Avon Advisory Planning Commission Meeting
January 26, 2026 at 6:30 pm
at Avon Town Hall

Planning & Building Department Staff Report

Planning & Building Department Staff Report

Planning & Building Department Staff Report

Exhibit B2 – Revised Proposed Site Plan (Received 2-Jan-2026)

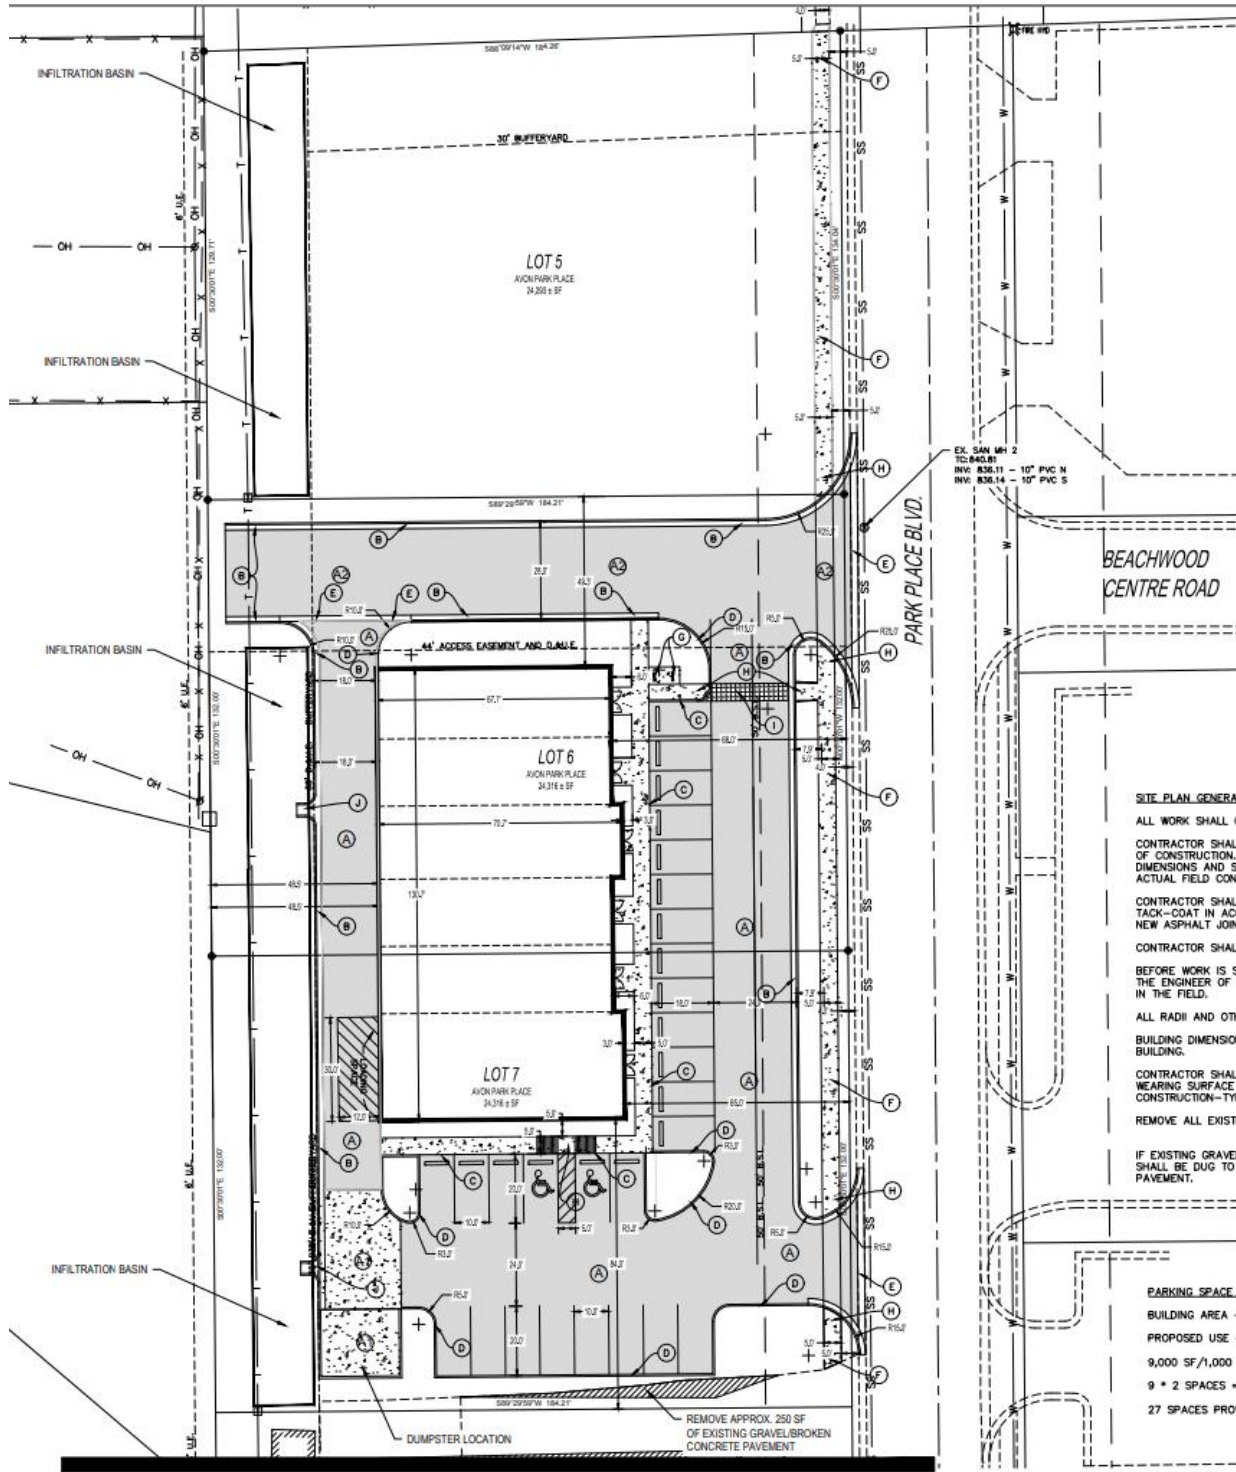
2. Per comments from the Department of Public Works and UDO 2.10(L), an extension of the business collector street (Beechwood Centre Road) identified in the Town of Avon Thoroughfare Plan must be constructed with development of this site. The site plan will need to be revised to relocate the proposed improvements to accommodate said street extension.

4. There appear to be discrepancies between the submitted site plan and building elevations in that the submitted building elevations appear to show six entrances on the east facade, but the site plan shows only four. Please make sure these plans match.

12. Per UDO Table 6.1, 90-degree angle parking requires 20-foot deep spaces, however, 18-foot deep spaces are shown in one of the rows. A variance or waiver can be requested, or the plans will need to be revised accordingly.

15. Per UDO Table 6.4, a development providing parking spaces within a range of 26 to 50 must provide a minimum of two (2) accessible parking spaces meeting the standards of UDO 6.12(E). No such spaces appear to be indicated on the plans. Please revise the plans accordingly.

18. Per UDO 6.11(D)(3), the first twenty (20) feet of a drive must be kept free from parking maneuvers. The parking space at the southeast corner of the site would violate this requirement. Please revise plans accordingly.

19. Per UDO 6.5(A), a minimum five (5)-foot wide landscaped strip is required around the perimeter of all principal buildings exclusive of doorways and loading areas. The west façade and portions of the east façade do not appear to meet this requirement. Please revise plans accordingly.

Exhibit B – Revised Site Plan (5-January-2026)

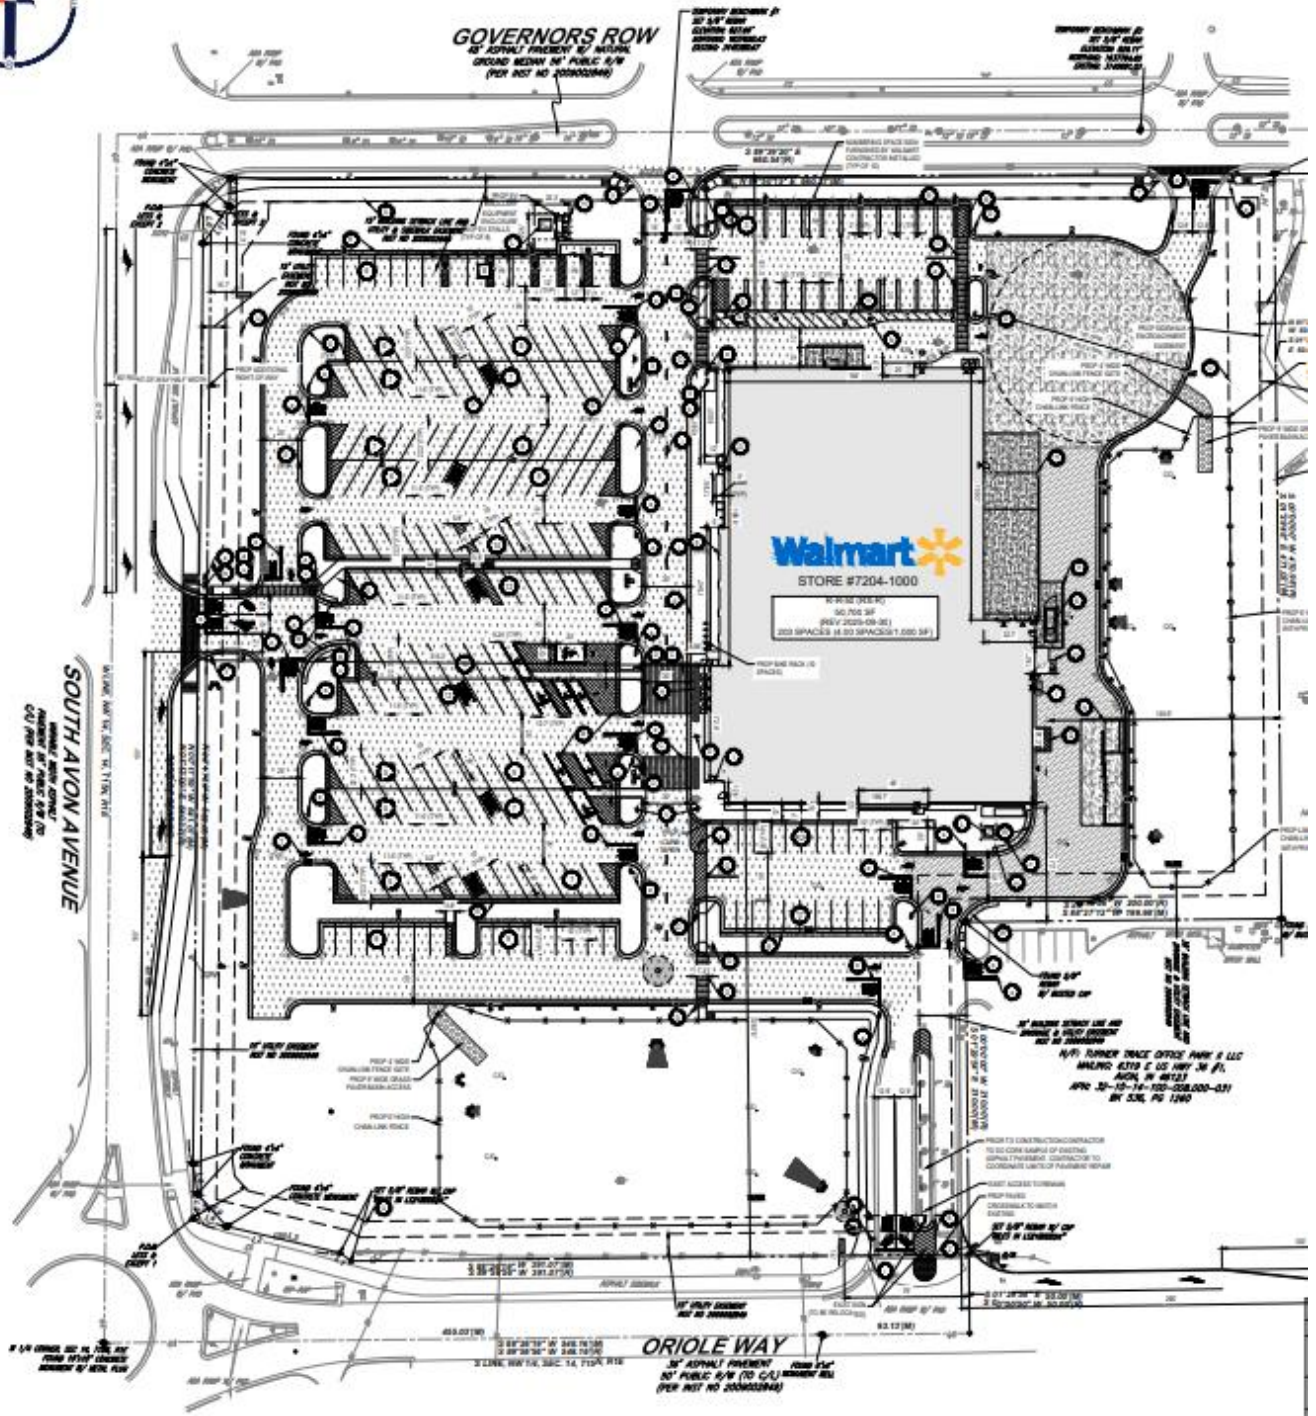
a) **Parking:** The site plan indicates the provision of 225 off-street vehicle parking spaces, with eight (8) of those being reserved accessible spaces. UDO Table 6.3 specifies that a minimum of 2.5 spaces per 1,000 square feet of gross floor area for a grocery store or other retail use, thus, a minimum of 127 spaces would be required for the proposed 50,700-square foot store. Based on the overall number of spaces provided, a minimum of seven (7) reserved accessible spaces would be required.

revised site plan shows bicycle racks in a compliant location, the plan only indicates five racks. At least one additional rack would be required.

Exhibit C1 – Revised Landscape Plan (2-January-2026)

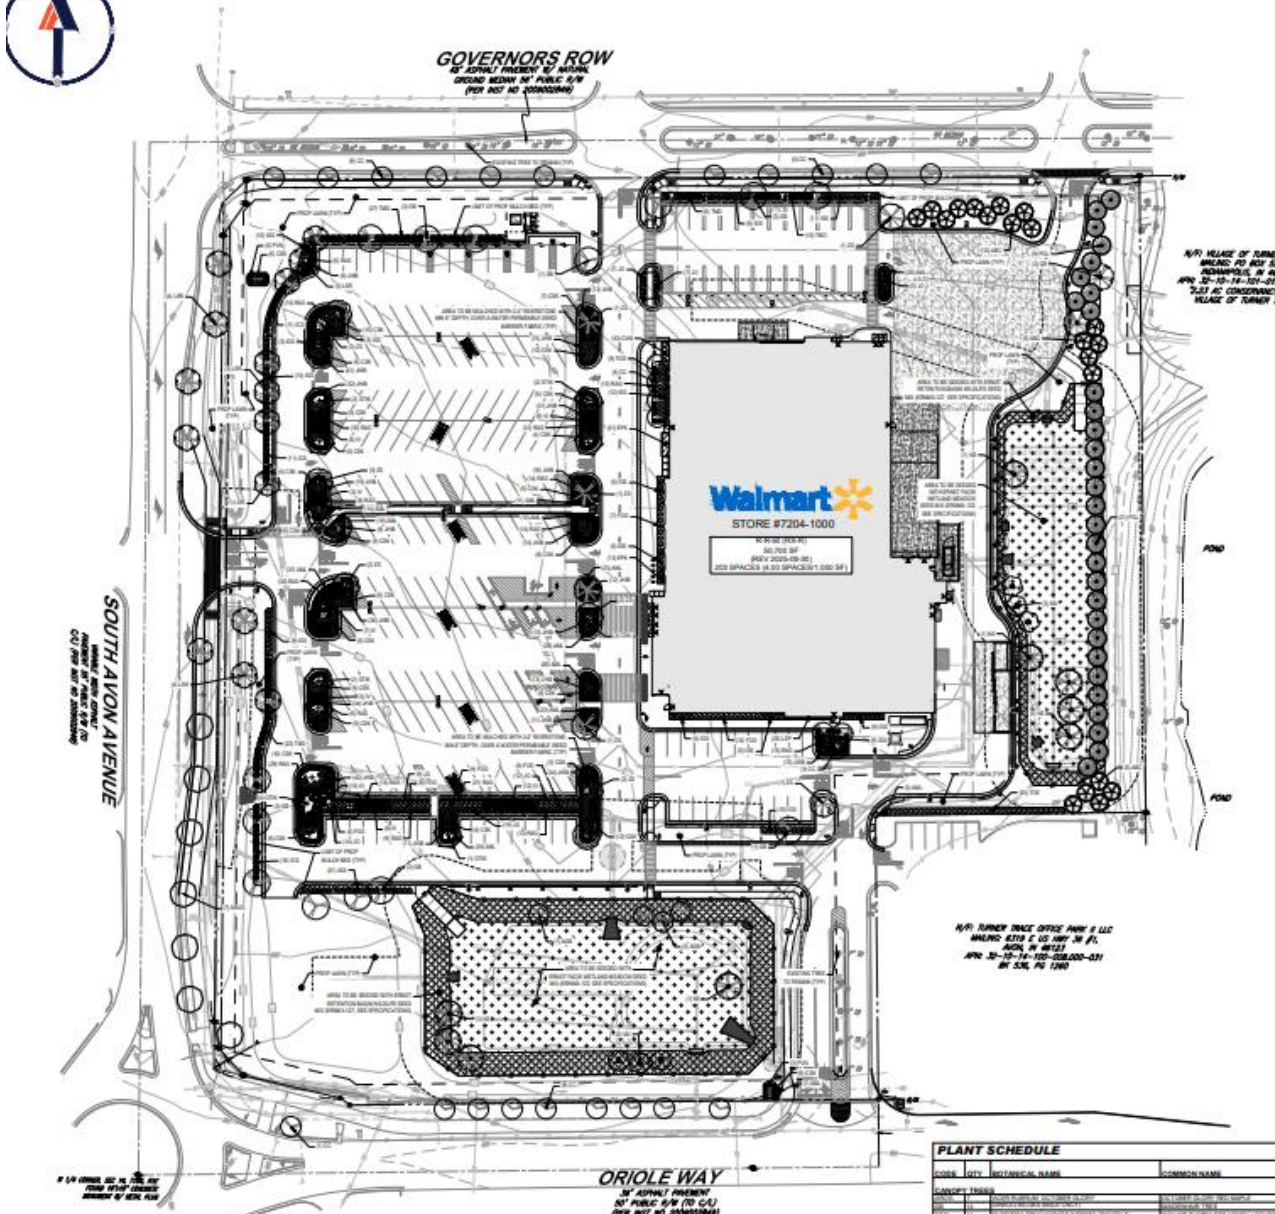
Per UDO 6.5 (A), a minimum five-foot planting area must be provided around the perimeter of the building, excluding access to the buildings, such as loading areas and doorways. The landscape plan submitted subsequent to TAC review has increased the proposed foundation planting areas, but is still deficient along several portions of the building (see Exhibits C1 & C2).

Per UDO 6.7(B)(4), each parking lot landscape island must have a minimum of one tree. The revised landscape plan is still deficient of this standard.

A further revised landscape plan should be submitted to demonstrate compliance with the foundation planting and interior parking lot landscaping requirements.

2. Prior to issuance of a building permit, a revised landscape plan shall be submitted, requiring approval by the Administrator, indicating compliance with all landscaping standards of the UDO.

Exhibit E – Aerial Photo w/ Measurements of Proposed Driveway Separation

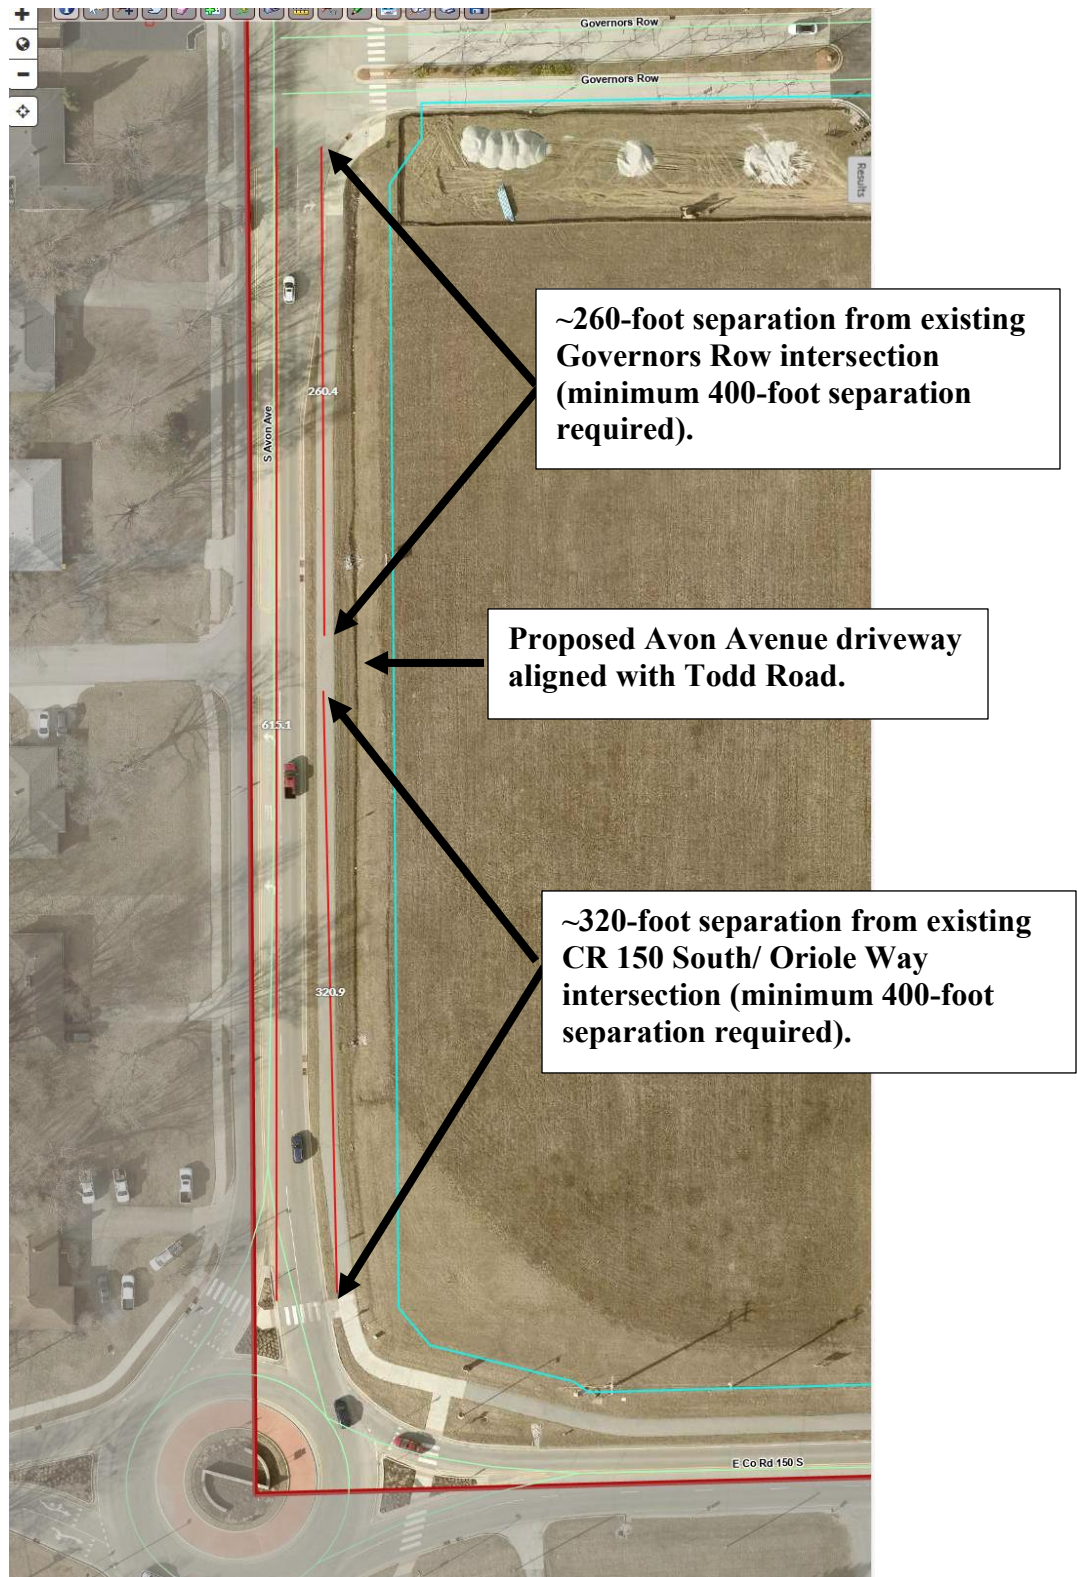
After evaluating the proposed development plan, the petitioner's TIS, and comments from the Town's consulting traffic engineer and Public Works Director, the Town opposes the requested waiver for direct access to Avon Avenue (see Exhibits E & G), and the Town has determined that the property owner should construct the following necessary improvements concurrently with development of the site.

While the property's frontage is not lengthy enough to meet the separation standards for a new direct access point to Avon Avenue, the site is already served by driveways onto County Road 150 South/ Oriole Way and onto Governors Row, both of which provide full access to/from Avon Avenue.

Exhibit D – Building Elevations Building A

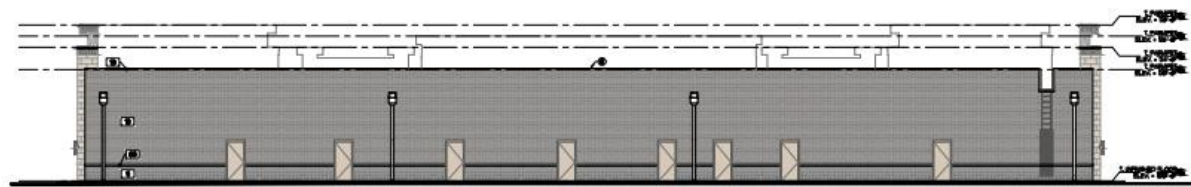
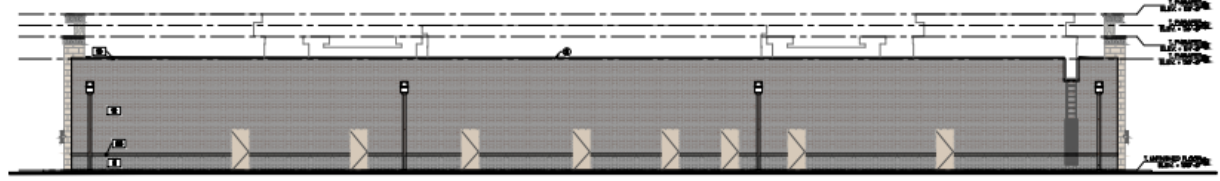
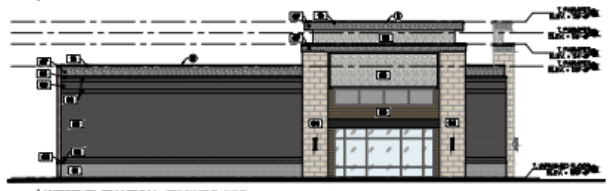
The proposed percentage of brick ranges from 36% on the front façade to 97% on the rear façade. Therefore, the overall appearance of the buildings will meet the intent of the UDO for having high-quality materials. While the front façade does not meet the 80% requirement, the change of materials offers a superior visual interest to warrant a deviation from the brick standard.
